**ADDENDUM NO. 1  
TO  
BRO –B080(29)  
BRIDGE NO 36400031  
PETTIS COUNTY, MISSOURI**

December 17, 2012

**QUISENBERRY ROAD BRIDGE**  
SEDALIA, MISSOURI

**FRAMING PLAN AND DETAILS**  
PETTIS CO. BRO-B080(29)

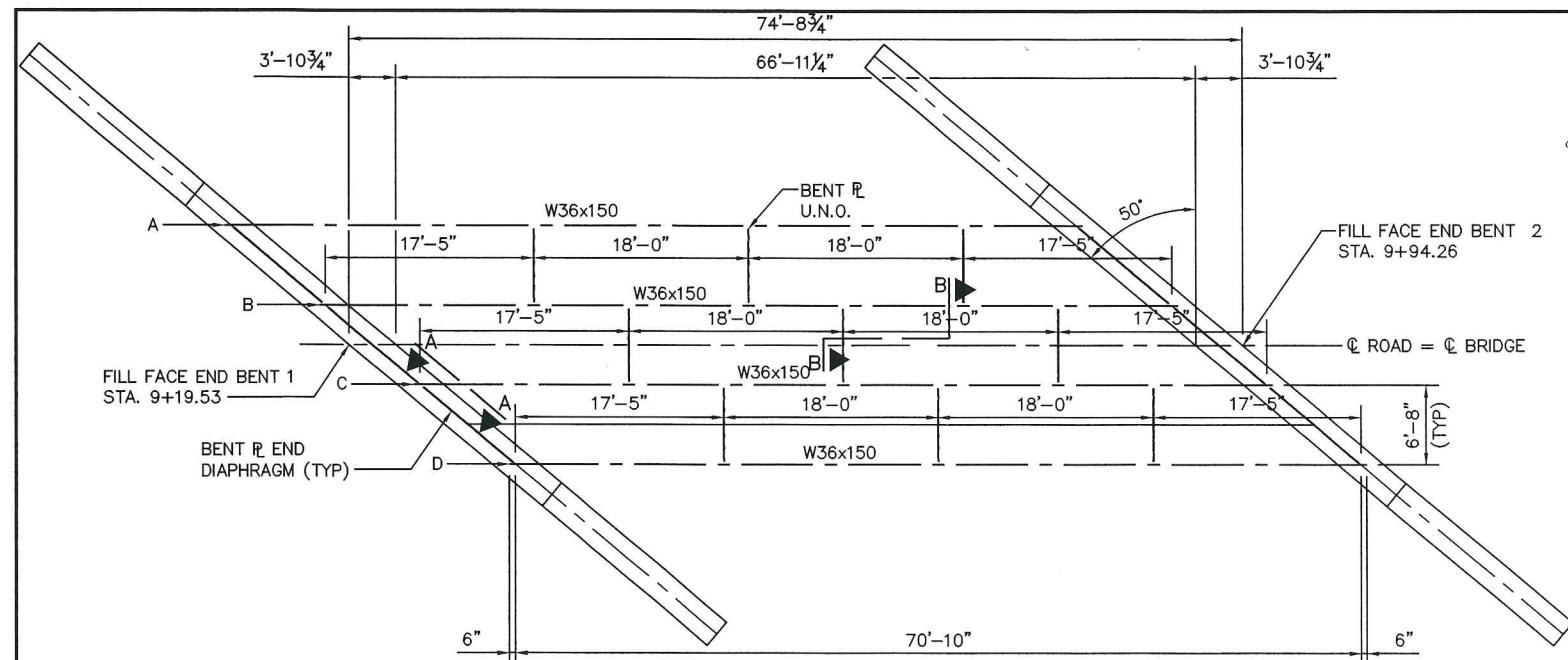
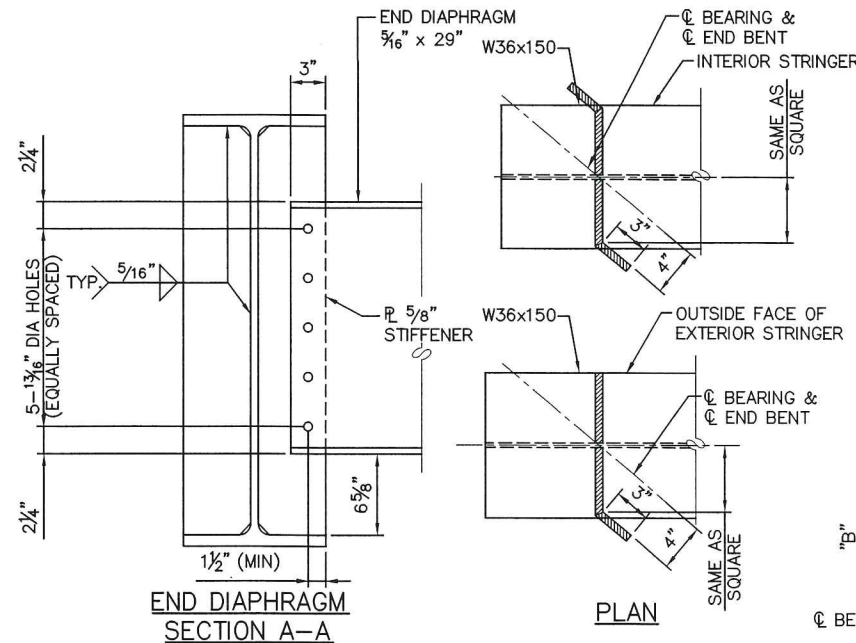
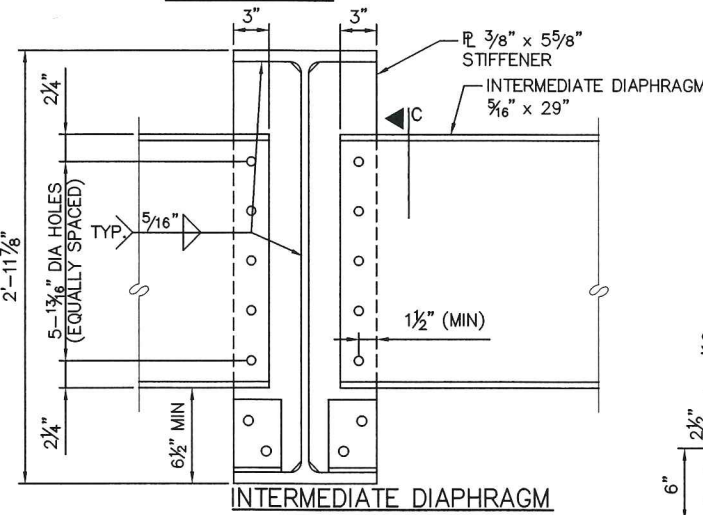
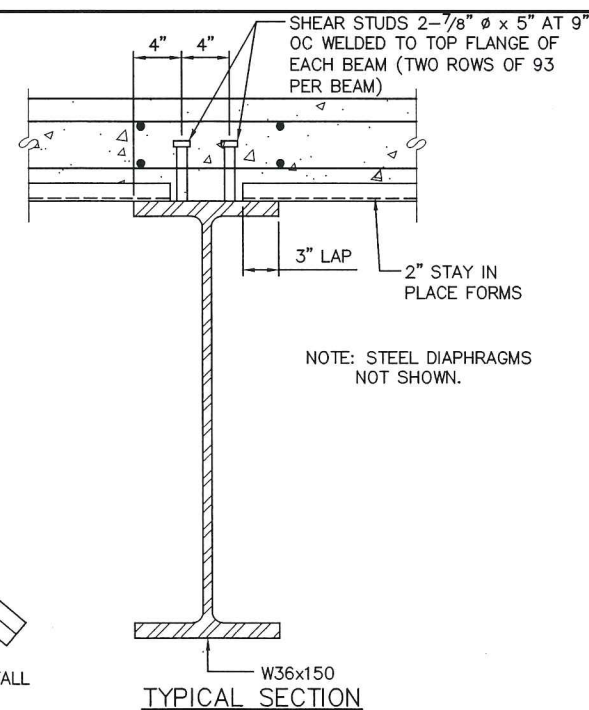
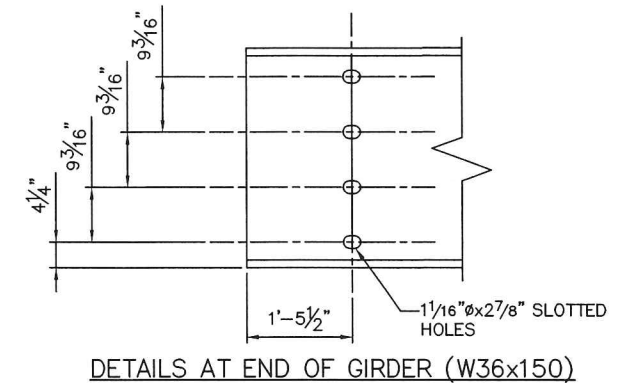
- 1) Sheet 2 of 18, Typical Roadway cross sections, the geotextile under the 4" aggregate base shall be removed, it is not required for this project. No revised sheet will be issued at this time.
- 2) Sheet 6 of 18 revised bid items, item 26, "SL-1 Rail on Bridge". Revised sheet attached.
- 3) Sheet 10 of 18, intermediate diaphragms have been revised to be square, revised connections for the end diaphragms, 5/16" bent plate shall be used for all diaphragms. Revised sheet attached
- 4) Sheet 12 of 18, revised spacing of the SL-1 rail posts to be 8' - 4", pay length is now 75'-0", per side. Revised sheet attached.
- 5) Sheet 12 of 18, Section A-A anchor bolt diameter shall be 1". Revised sheet attached.
- 6) Revised Itemized Proposal Forms are attached. Bidder shall use these forms to submit their bid.

AT THE CONTRACTORS OPTION THE ALTERNATE PLATE GIRDER MAY BE USED IN LIEU OF THE W36x150. ALL STRUCTURAL STEEL SHALL BE ASTM A709 GRADE 50. THE BOTTOM FLANGE WILL BE SUBJECT TO CHARTY V NOTCH IMPACT REQUIREMENTS. ALL PLATE GIRDERS SHALL BE SHOP CAMBERED. STRUCTURAL STEEL QUANTITIES ARE BASED ON THE W36x150 BEAM. STIFFENERS WILL BE REQ'D AT SAME SPACING AS ROLLED BEAM SHOWN. NO MEASUREMENT WILL BE MADE TO DETERMINE THE WEIGHT OF STRUCTURAL STEEL USED IN THE PROJECT. PAYMENT WILL BE BASED ON THE QUANTITY SHOWN IN THE SUMMARY OF QUANTITIES.
